Airport *Link*

Request for Project Change

MAY 2008

Queensland
Government

Figure 4-12
Chalk Street Worksite

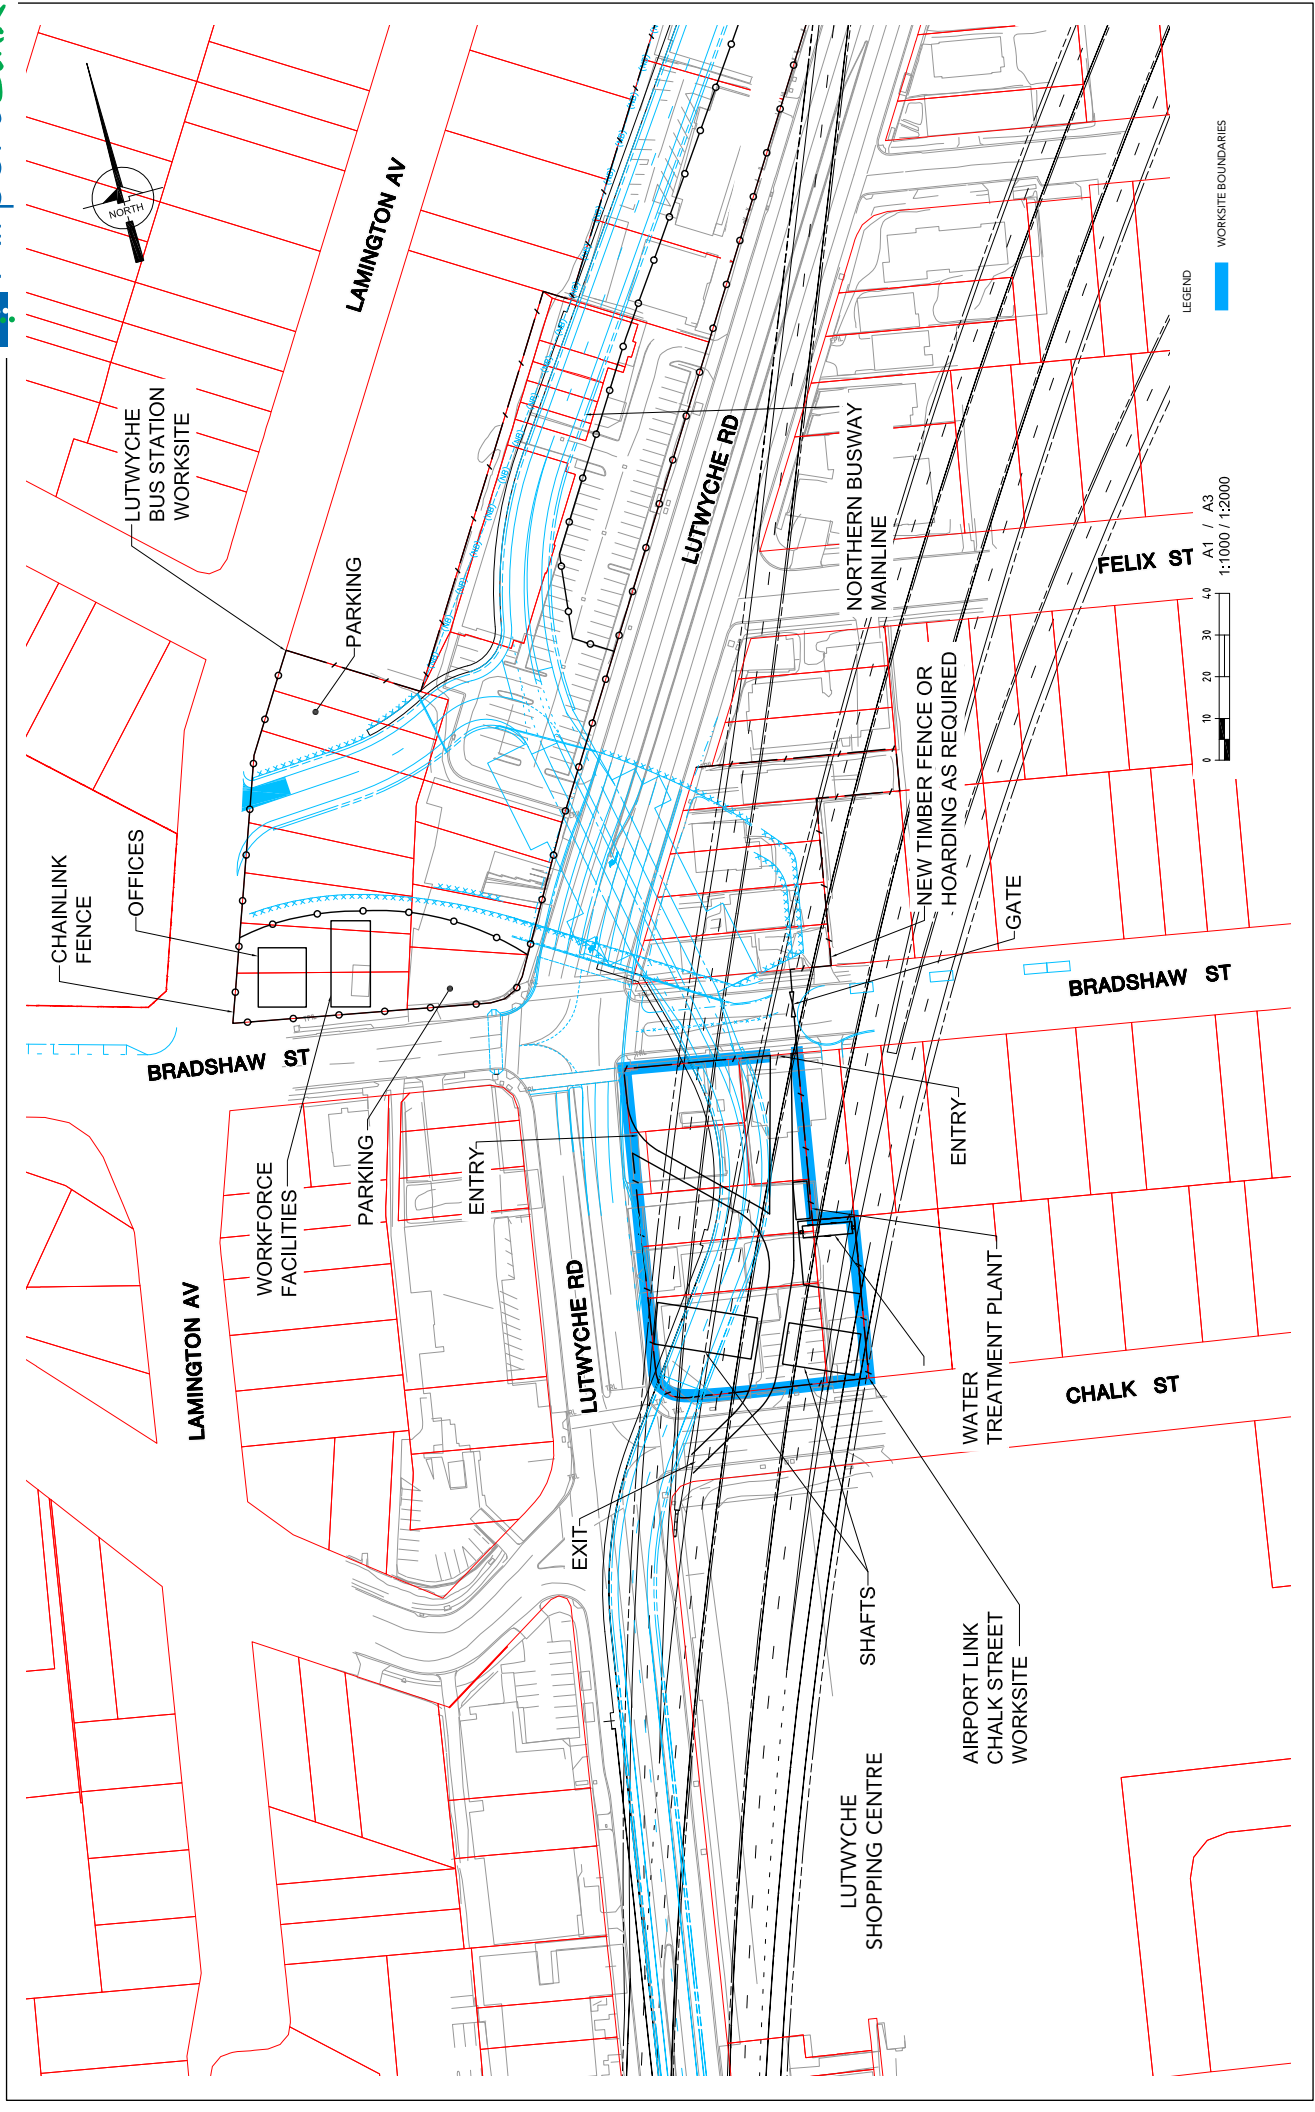
The worksite established at Chalk Street for the Northern Busway would be expanded to receive, disassemble and remove the TBMs, in components, from the mainline tunnels driven from the Clayfield worksite. The scale of the Chalk Street worksite would increase, requiring effective mitigation measures to address the potential impacts of TBM disassembly and removal. There would be a small quantity of spoil removed from this worksite for Airport Link works, arising from TBM break-through and worksite establishment.

The Changed Project would also require an additional worksite on the eastern side of Lutwyche Road between Chalk Street and Bradshaw Street (**Figure 4-12**). This worksite would be shared with the Northern Busway Project. The establishment of this worksite would include two large vertical shafts for the extraction of the TBMs arriving from the Clayfield worksite.
